# TDECQ Calculation According to D3.1

IEEE 802.3dj, IEEE 802 July Plenary Meeting

Comments addressed: 95, 96, 97, 103, 205, 227, 229, 230, 263, 264, 267, 276, 287

# Methodology

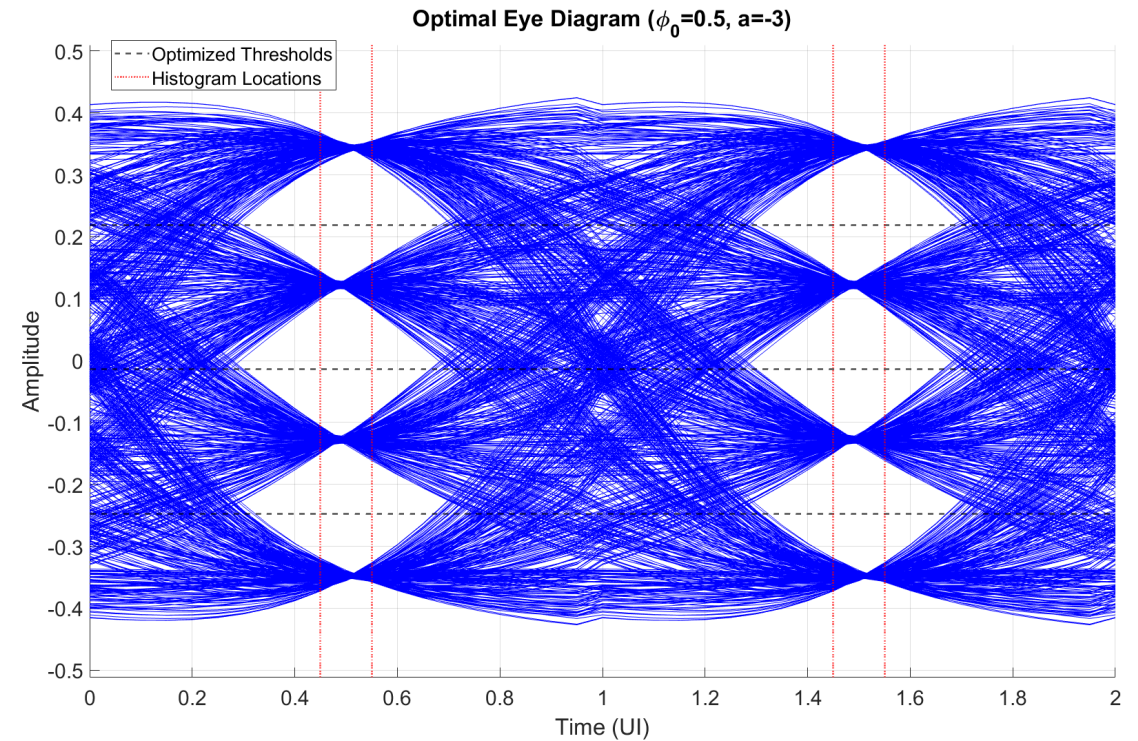
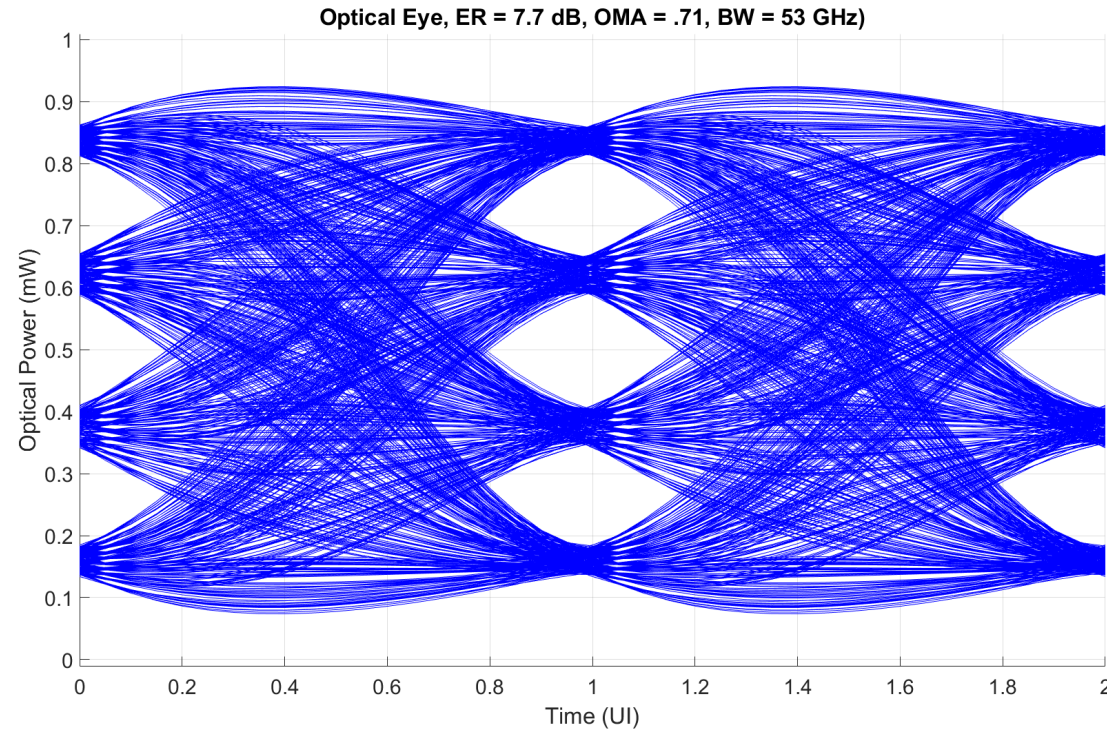
- Appendix 1 gives details on an MMSE algorithm that achieves repeatable results and has been implemented by several parties
- There is no evidence that blind search gives substantially better or different results
- The qualifier that better results can be used should be eliminated
  - Even if better results can be achieved, that should not be adopted unless a methodology is specified to enable repeatability
  - If the committee desires, algorithms to improve results could be investigated
  - For example, minimize mean squared error at multiple points:
    - $\phi_0 - .05T$  and  $\phi_0 + .05 T$  ( $e^2 = e_L^2 + e_R^2$ )
    - or  $\phi_0$ ,  $\phi_0 - .05T$ , and  $\phi_0 + .05 T$  ( $e^2 = e_0^2 + e_L^2 + e_R^2$ )
    - Minor change from current algorithm

# Sampling Phase Sensitivity and Threshold Deviation Limits

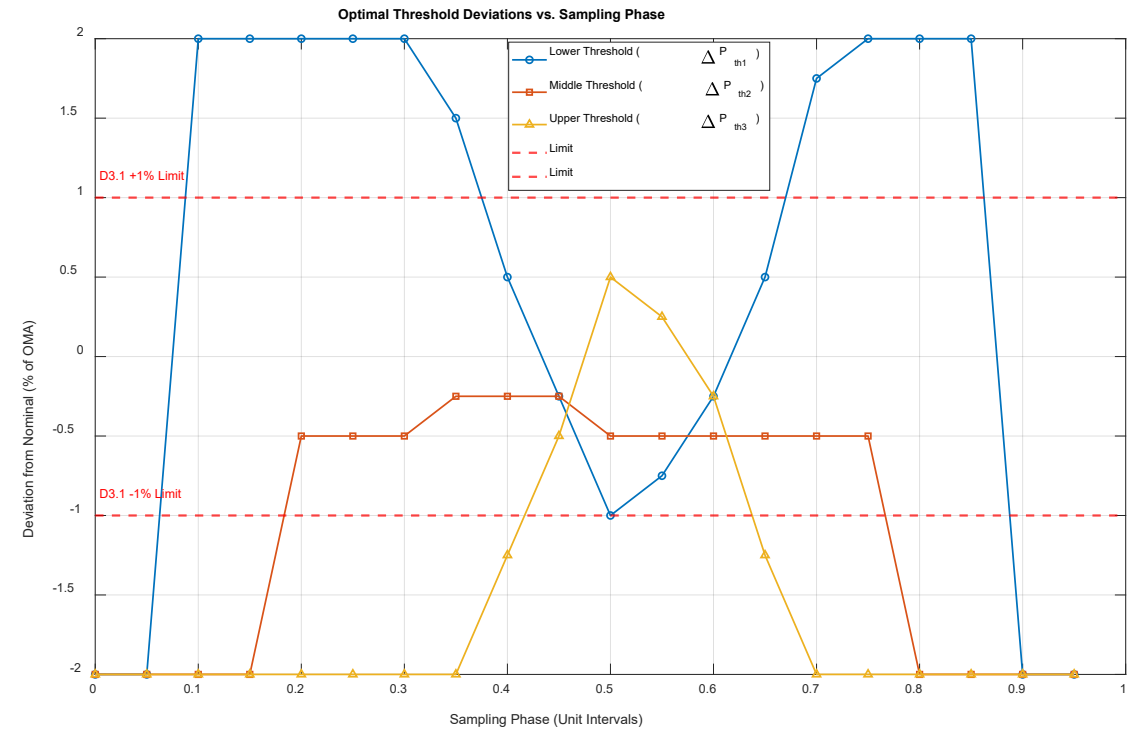
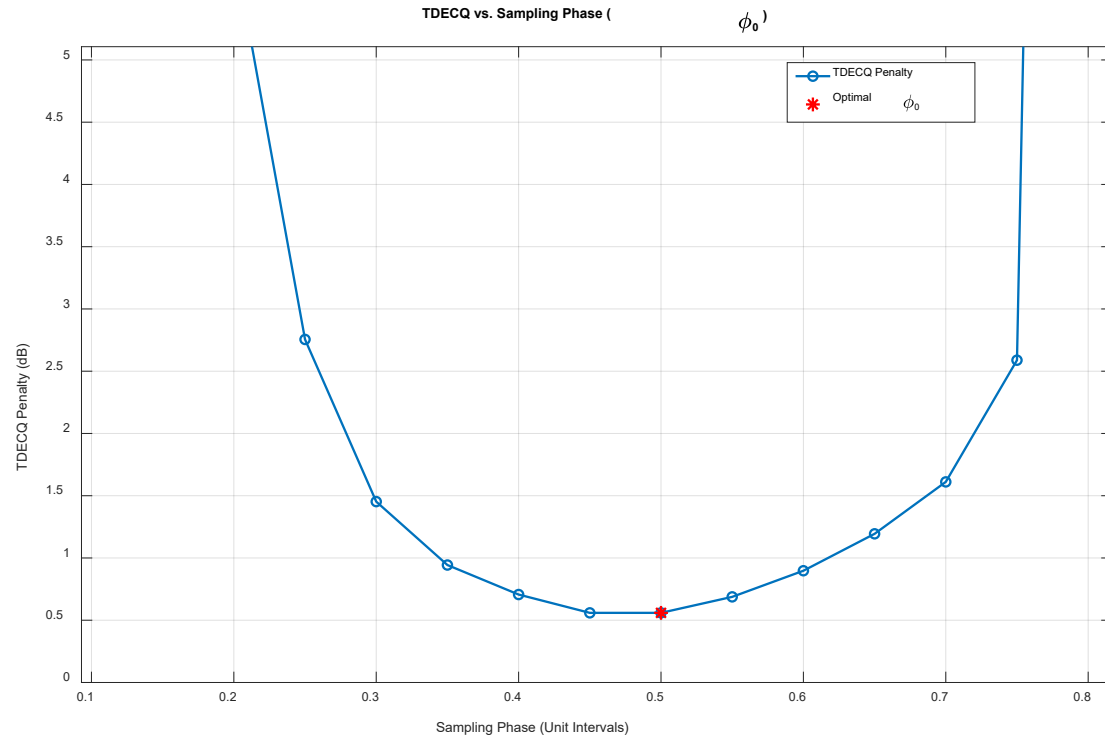
- Sampling phase sensitivity is well behaved (bowl shaped); No need to search over entire range
- Threshold deviations near optimal sampling phase are within  $\pm 1\%$  limits
  - However, at optimal phase, deviation of lower threshold reaches limit. May want to expand limits
